Date: May 13, 2021

Subject: Battery Compatibility With Dexter DX Series Electric/Hydraulic Actuators

SERIAL NUMBER

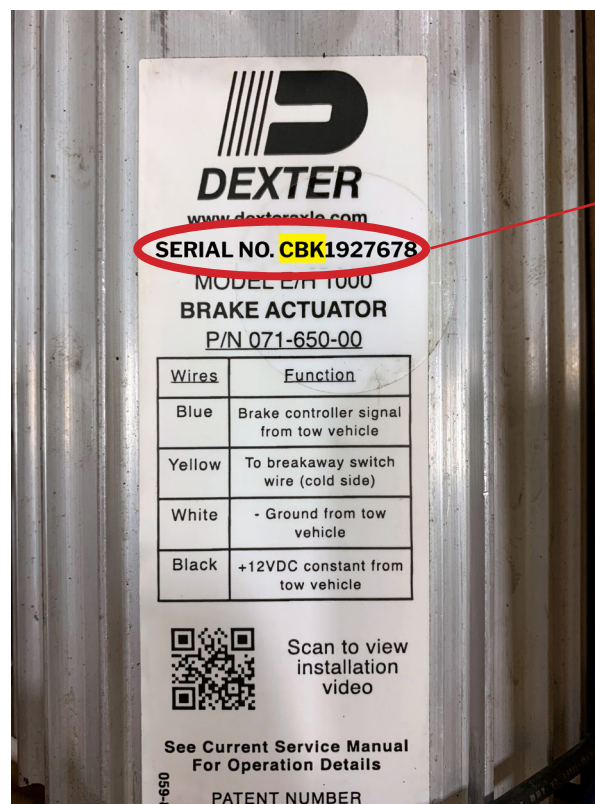
In March of 2021 Dexter introduced an upgraded feature to the DX Series E/H Actuators that allows compatibility with these newly introduced solar charging systems. For trailers utilizing these alternate solar power sources we suggest ensuring the DX Series E/H Actuator's serial number begins with "CBK" and has a manufacturing date of March 2021 or later.

If the DX Series E/H Actuator's serial number begins with anything other than "CBK" and has a manufacturing date of February 2021 or earlier, the break-away circuit should utilize a battery designed specifically for break-away applications to ensure proper function.
